# Access Compliance Report

## Public Rights-of-Way

### (Curb Ramps)

Intersection ID: 30490	Main Street: BRAMWYCK_DR	Cross Street: QUAIL_PARK_DR	Location: SW
ADA ID: A6ABAAF34A7A	Ramp Type: PerpDiag	Initial Pass/Fail: Fail	Overall Compliance: No
		Severity Score: 10

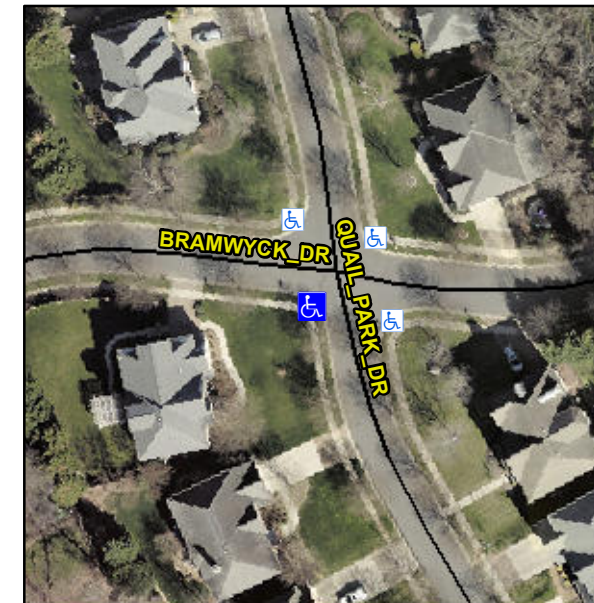
**Not Found, R304.5.1, R304.5.3**

Compliance	Description	Data	Compliance	Description	Data
N/A	Ramp Length (in)	49.0	Yes	Ramp Slope (%)	5.4
No	Ramp Width (in)	40.0	No	Ramp XSlope (%)	2.4
N/A	Flare Type LT	N/A	N/A	Flare Type RT	N/A
N/A	Flare Slope LT (%)	N/A	N/A	Flare Slope RT (%)	N/A
N/A	Flare Traversable LT?	N/A	N/A	Flare Traversable RT?	N/A
N/A	Landing Length (in)	N/A	N/A	DWS Provided?	N/A
N/A	Landing Width (in)	N/A	N/A	DWS Contrast?	N/A
N/A	Landing Slope (%)	N/A	N/A	DWS Length (in)	N/A
N/A	Landing X Slope (%)	N/A	N/A	DWS Full Width?	N/A
N/A	Landing Curb? (Y/N)	N/A	N/A	DWS Offset (in)	N/A
N/A	Shared Landing?	N/A			
N/A	Gutter Ponding?	N/A	N/A	Gutter Slope (%)	N/A
N/A	Gutter Lip Ht (in)	N/A	N/A	Gutter X Slope (%)	N/A
N/A	Painted X Walk1?	No	N/A	Painted X Walk2?	No
	X Walk 1 Direction	To SE		X Walk 2 Direction	To N
N/A	X Walk 1 Width (in)	N/A	N/A	X Walk 2 Width (in)	N/A
	X Walk 1 Slope (%)	4.8		X Walk 2 Slope (%)	3.0
	X Walk 1 X Slope (%)	3.6		X Walk 2 X Slope (%)	2.6

**Remove & Replace Curb Ramp With Two New Directional Ramps or Equivalent.**
